Service Manual

Supplement

SL-P1200X

Note:
This supplement has been issued to inform you that the balanced output P.C.B. have been changed in units having serial number suffixes "Q" or later. (Refer to "How to read the serial number" shown at right.)

K BALANCED OUTPUT CIRCUIT

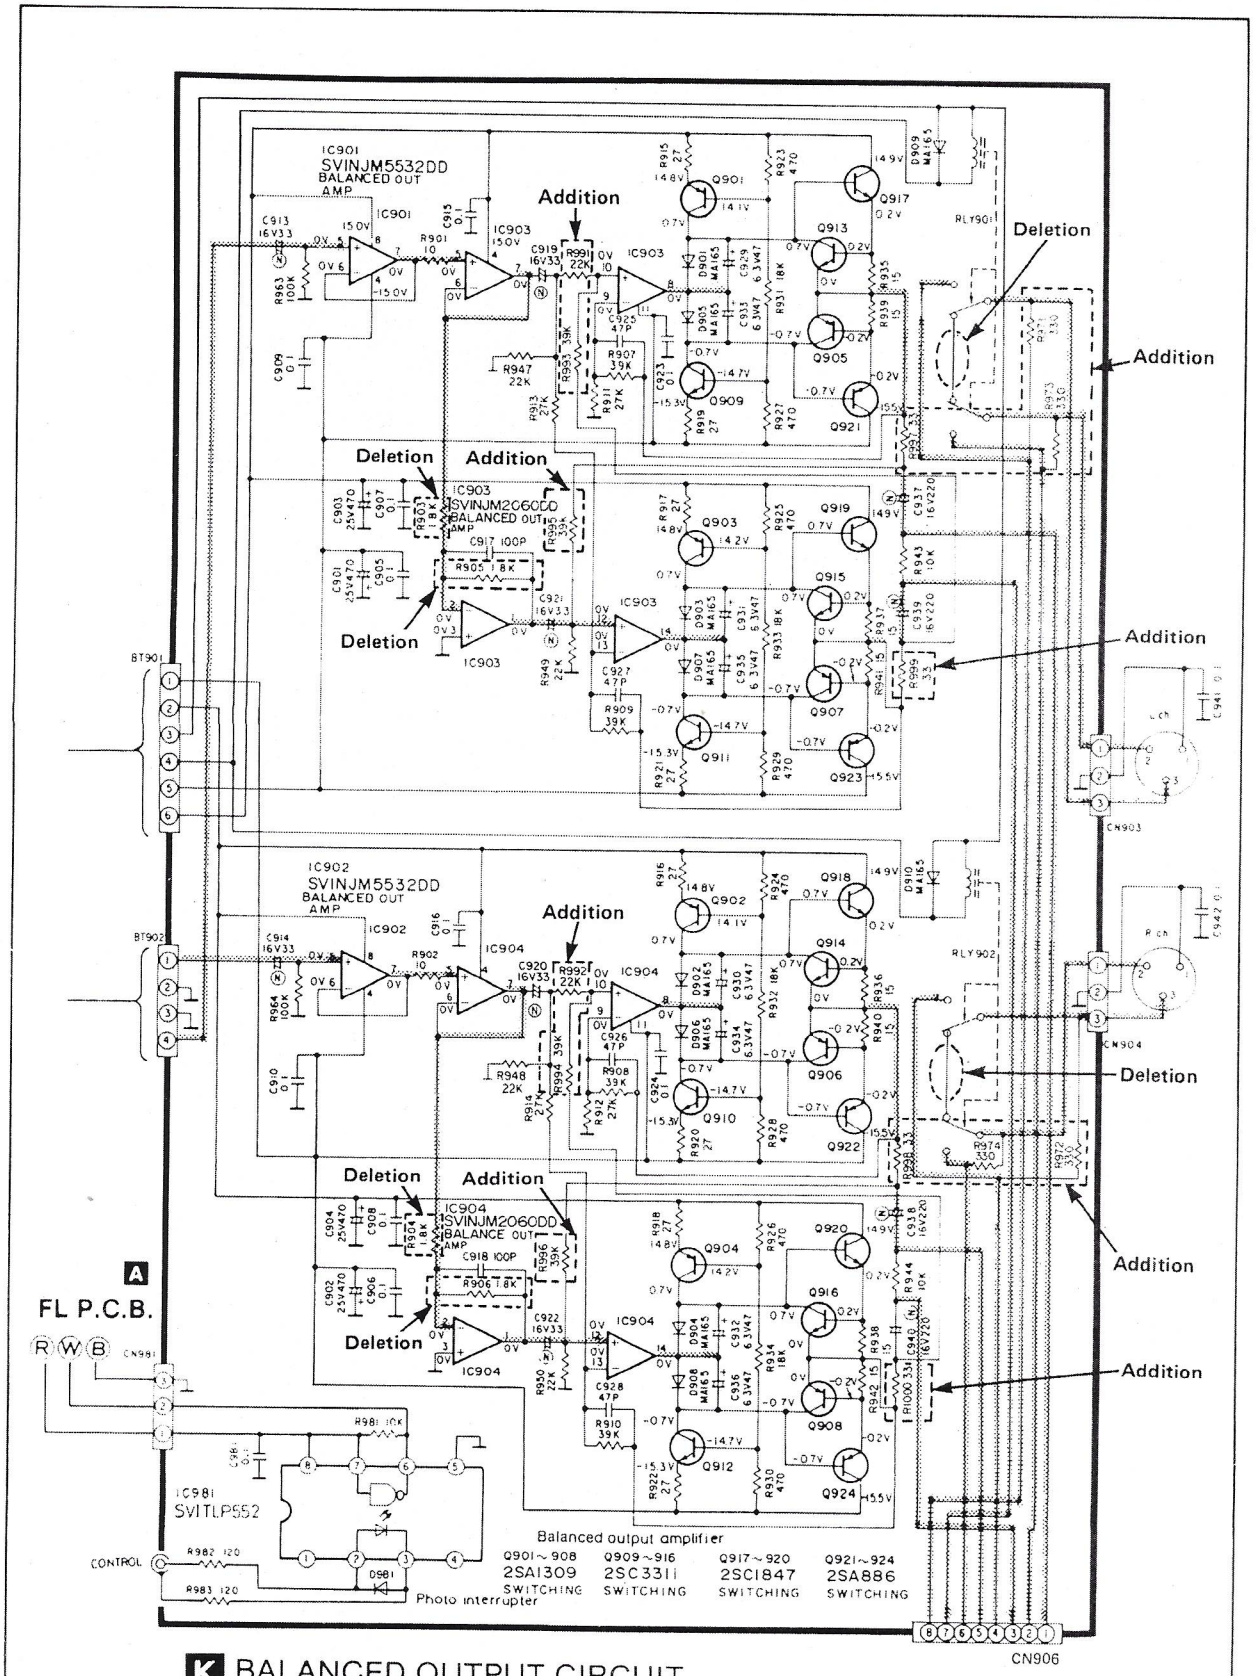
(ORIGINAL)

(NEW)

■ PRINTED CIRCUIT BOARDS

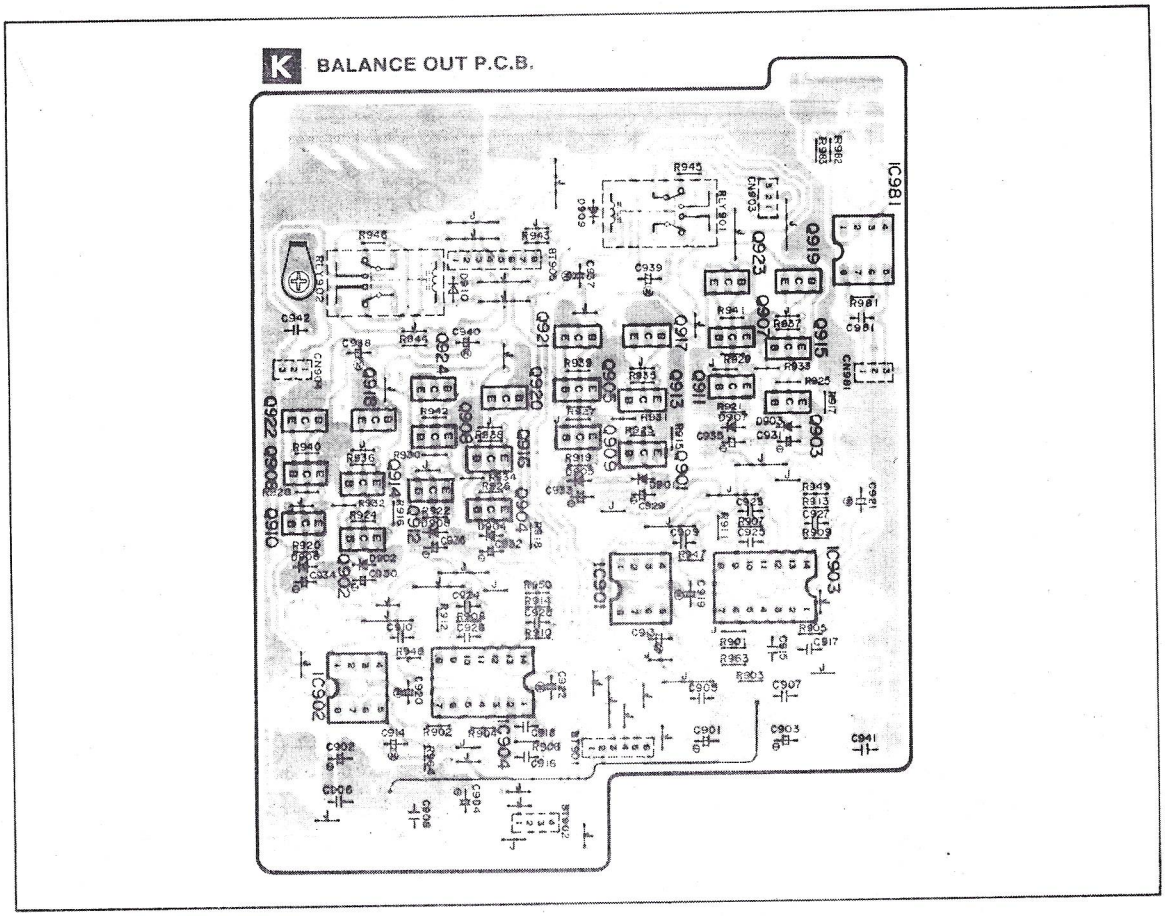
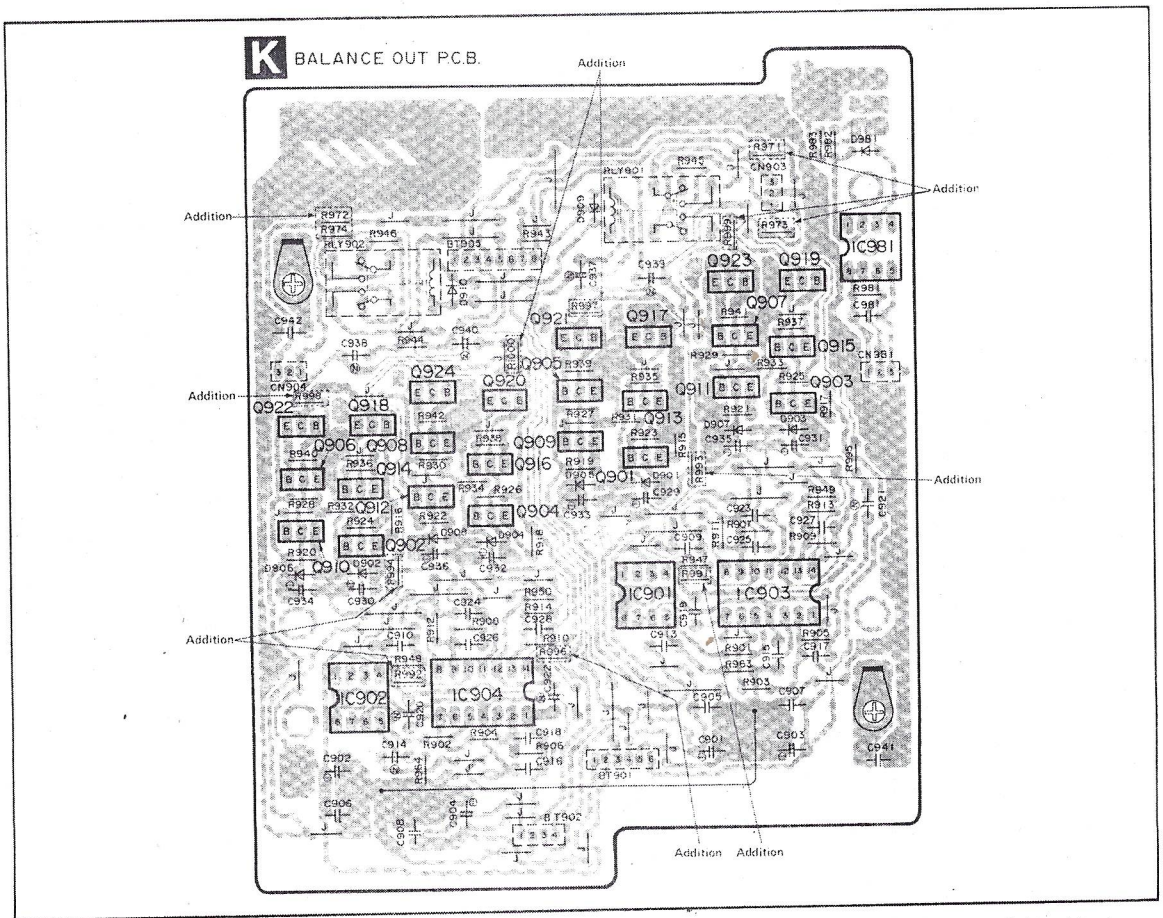
(ORIGINAL)

(NEW)
